CITY OF KELOWNA

MEMORANDUM

TO AMEND THE EXISTING OFFICIAL COMMUNITY PLAN
FUTURE LAND USE DESIGNATION OF MULTIPLE UNIT
RESIDENTIAL-LOW DENSITY TO MULTIPLE UNIT
RESIDENTIAL-MEDIUM DENSITY;

TO CONSTRUCT A 49 UNIT, 3 STOREY APARTMENT
HOUSING DEVELOPMENT ON THE SUBJECT PROPERTIES

SITE PLAN

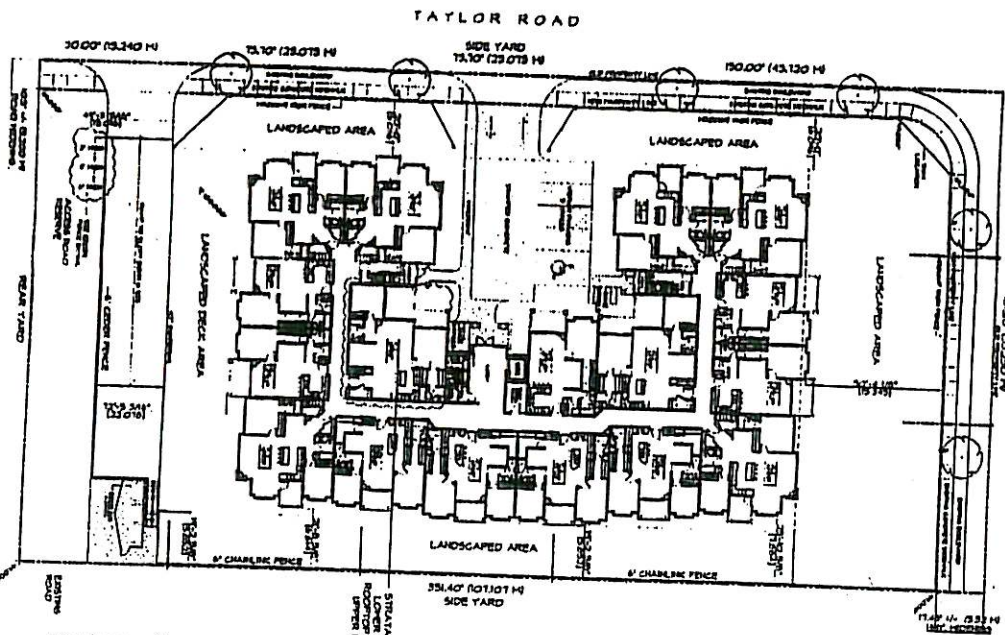
^A The applicant has incorrectly shown 5,294 m² as the net lot area, for determining F.A.R. However, the actual net lot area should be 5,294 m² less 392 m² of dedication for the lane = 4,902 m².

- Loading, garbage and other ancillary services are located at the rear of buildings.
- It is not clear whether or not utility service connections will be screened from view as they are not shown on the development plans.

- The developer has proposed some amenity space; however, it is located in close proximity to Hwy.33 and does not appear to serve any functional outdoor space needs for the residents of the proposed development.

- Vehicle access and on-site circulation minimizes interference with pedestrian movement.
- Vehicle access to and from the development will conflict with traffic flow on the future lane. Access should be re-designed to reduce potential conflicts.
